MAX96724/MAX96724F/MAX96724R DEV_REV=1 (B-0A) ERRATA SHEET

Corresponds to Data sheet 19-101575; Rev 4; 1/2023 Errata

DEV_REV=1 (per reading of register 0x4C)

4) GMSL link lock times may increase if DES and SER are powered up or released from reset with significant delay relative to each other

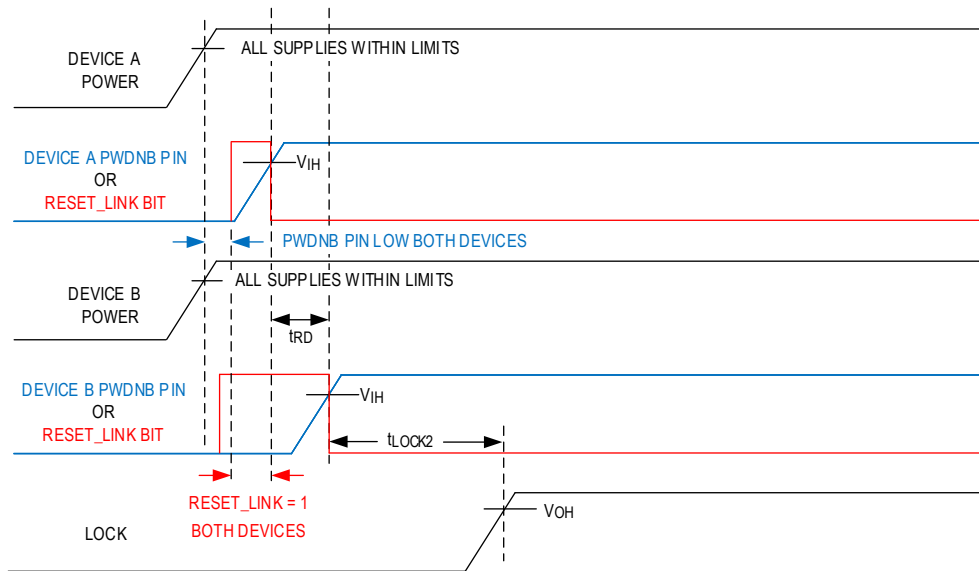
Description:

Due to timeouts in the link layer, GMSL link lock times (t_{LOCK2}) may increase above 160ms¹ (or 200ms²) if deserializer (DES) and serializer (SER) links are powered up or released from reset with more than 90ms¹ (or 70ms²) delay (t_{RD}) relative to each other. This issue applies only if the SER is released from reset first.

Note 1: The first values ($t_{\text{LOCK2}} > 160\text{ms}$ and $t_{\text{RD}} > 90\text{ms}$) refer to the links in which DES and SER devices have typical lock time $< 55\text{ms}$.

Note 2: The second set of values ($t_{\text{LOCK2}} > 200\text{ms}$ and $t_{\text{RD}} > 70\text{ms}$) are for the links where the typical lock times of either the SER or DES are greater than or equal to 55ms.

In certain configurations, devices must be programmed after the power-up (e.g. to set the link rate) and the link must be reset to trigger the configuration change. As the user-issued link resets may interrupt on-going link lock attempts, it is critical to ensure that link resets are issued on both SER and DES sides and are overlapping in time as shown on the diagram below. Without overlapping resets of both SER and DES devices, one of the devices may have to wait to complete its timeout sequence before it becomes available for the next link lock attempt. Overlapping link resets on SER and DES devices should be released within t_{RD} time window relative to each other if the SER is released from reset first, similar to the power up t_{RD} requirement.

Workaround:

1. Implement DES and SER programming sequence such that DES is powered up or released from link reset before SER. If link resets are used, make sure that they overlap.
2. If SER is powered up or released from link reset after DES, implement DES and SER programming sequence to power up or release DES and SER link resets within $t_{RD} < 90\text{ms}$ (or $t_{RD} < 70\text{ms}$) of each other. If link resets are used, make sure that they overlap.
3. If workarounds #1 or #2 cannot be used, contact factory for further guidance on optimizing the lock time.
